**Meeting at 9:00 on 24 November 2016**  
**Level 28 - Majestic Centre, 100 Willis St, Wellington**

## ACTIONS

Pavement marking – 1000 x 1500 mm

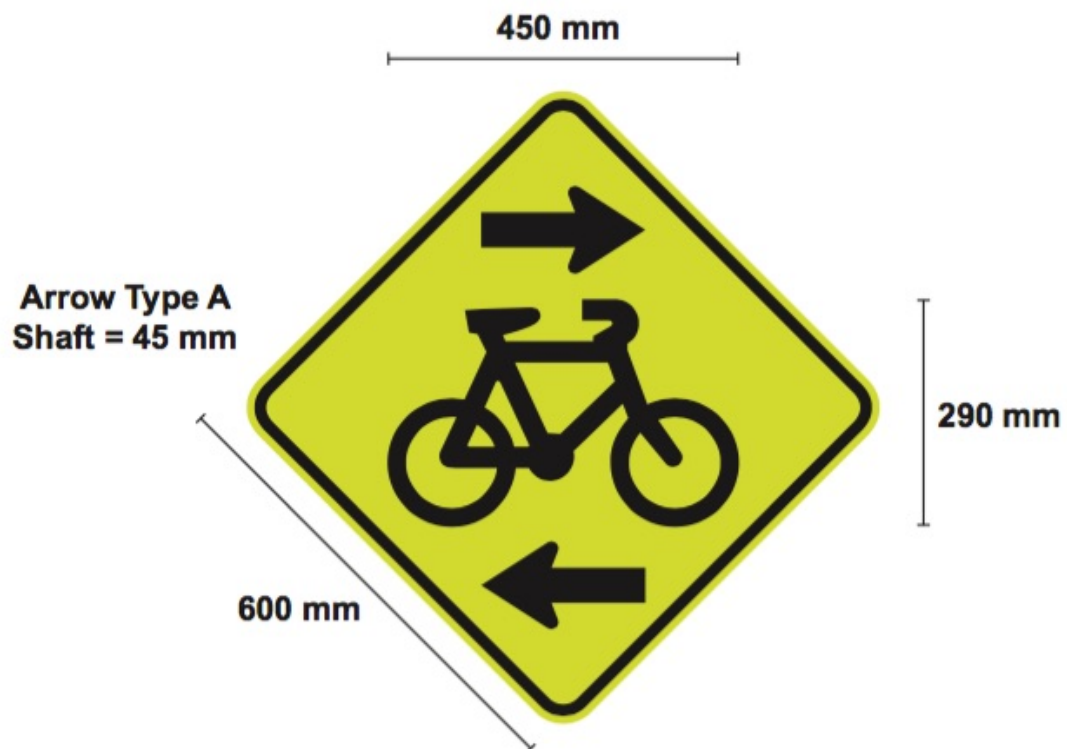
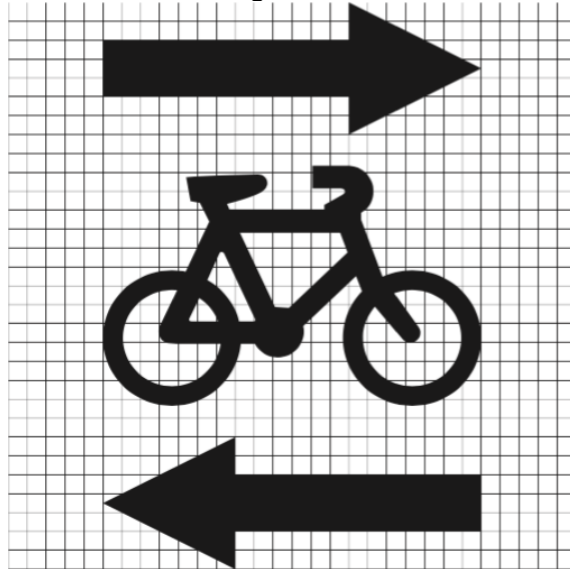
A. To approve the pavement marking and sign below for use at vehicle entrances crossing cycle paths:

(The scale of the arrows on the marking can be reduced to be closer to the proportions on the sign.)

(b)

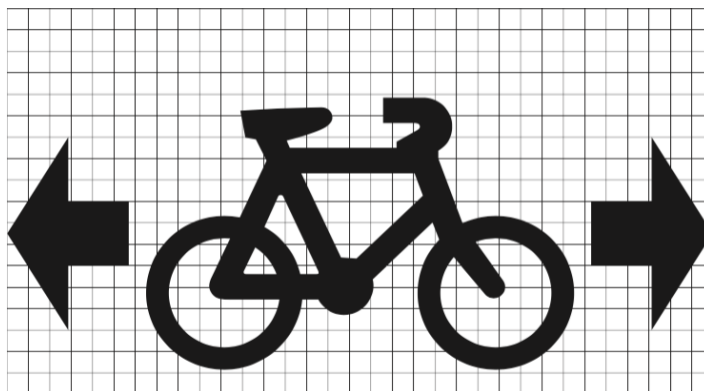
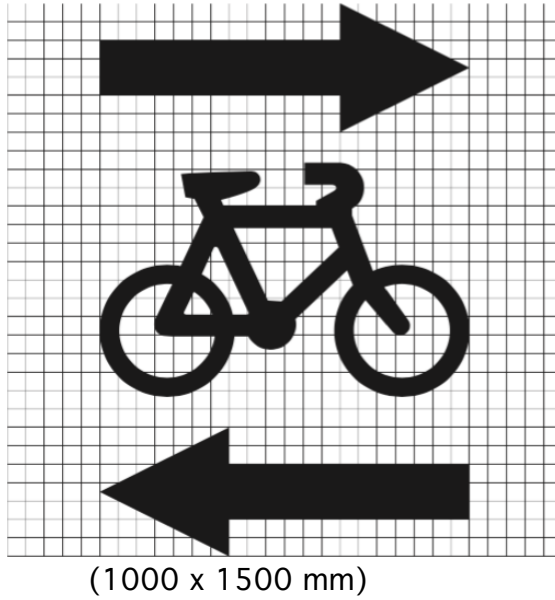
The pavement marking symbol was modified so that the wheels appear round. The reasons for this were:

- This marking will be used at driveways where the viewing distance is short and approach speed low, so that the elongated perspective of the standard road marking is not so important;
- The mock-up using the standard, elongated wheels, road marking symbol looked wrong;
- Using the standard, elongated road marking symbol takes up more space and the marking with the arrows above and below the cycle is about 2.5 metres tall. This makes the arrow on the top look a lot less significant than the arrow on the bottom, but it is the arrow on top that is arguably the most important.

The arrows are considered an important part of the marking, as they alert drivers to the fact that cyclists may be approaching from their left (when they might be inclined to look only for traffic coming from their right).

The principal concern is that this would create yet another cycle symbol template that could result in confusion for contractors and incorrect symbols being marked. It was also noted that whereas arrows above and below the symbol on the sign appear relatively small, because they fit into a lozenge shape, the arrows above and below the symbol in the pavement marking are large. This represents a lot of paint at every driveway.

Marking (a) has already been applied by AT and Christchurch City as being better suited to a single marking at a vehicle exit. NZTA and Wellington City have used marking (b) as being better able to be fitted into a 1 m wide stripe in a trial of a potential crossing marking undertaken on the Hutt Rd.

The meeting approved pavement marking (b) and sign (a) for use at vehicle entrances crossing cycle paths. The scale of the arrows on the marking can be reduced to be closer to the proportions on the sign:

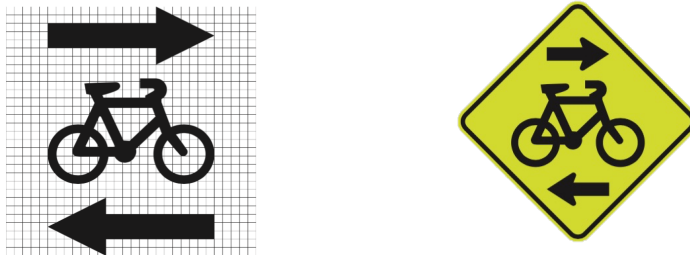
The current trial has looked at the effect of marking a series of 1 m wide stripes with 1 m separation across a wide vehicle exit. The trial has observed the effect of unclear priority on the behavior of motorists and cyclists. The preliminary finding is that the marking has made motorists more careful without making cyclists less careful:

- Before marking 32% of vehicles stopped before the cycleway
- After marking 68% of vehicles stopped before the cycleway.

The trial has shown, however, that the Emerald Green specification is too likely to darken and become dull and a brighter tone should be specified.

The meeting also agreed that the preferred colour specification for the green to be used on cycling facilities is Apple Green and the preferred red to be used on infrastructure for active modes is Signal Red.

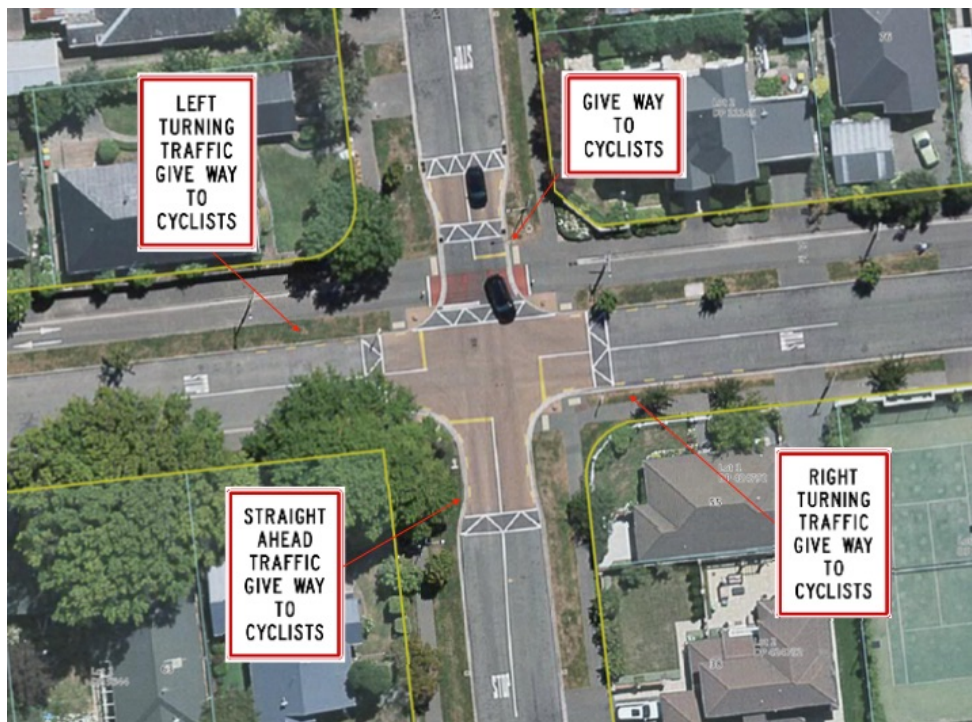
Five examples of Regulatory or Supplementary Signs for Give Way at cycle path intersections were circulated on 2 September. The supplementary 'TO CYCLISTS' has been installed on the Matai Street crossing in Christchurch City to inform motorists who they are giving way to. Prior to the installation of the supplementary sign there were numerous incidents of cyclists being cut off; following installation Christchurch City has not received a complaint.

The meeting agreed that the critical issue for the use of this supplementary is that it defines whom the motorist must give way to and could only, therefore, be used where no other traffic would cross.

The Matai Street West intersection with Harakeke Street is on the Christchurch Uni-Cycle major cycle route. The 4-way stop control has existed for years and so has the cycle path. To clarify to motorists that they are required to stop at the intersection and also give way to cyclists on the cycle priority crossing on the north side of the road, three of the Regulatory Supplementary signs indicated on the plan have been installed on separate poles near the Stop signs. The “Give Way to Cyclists” sign was not installed, as it would be confusing beside a Stop sign.

The meeting agreed that separate signage approved for intersections where motorists are required to also give way to cyclists on a cycle priority crossing at an intersection should be regulatory, rather than advisory.

After some discussion of preferences for using “cyclists”, “cycles” or just the cycle symbol, it was agreed that variations using the three options, as well as “pedestrians” or the pedestrian symbol, should be mocked up and tested in the simulator.

- **Regulatory supplementary sign:** 'TO CYCLISTS' for use with the TCD 11.4(5) cycle crossing; and
- **Regulatory Signage:** 'LEFT TURNING, RIGHT TURNING or STRAIGHT AHEAD TRAFFIC GIVE WAY TO CYCLISTS.
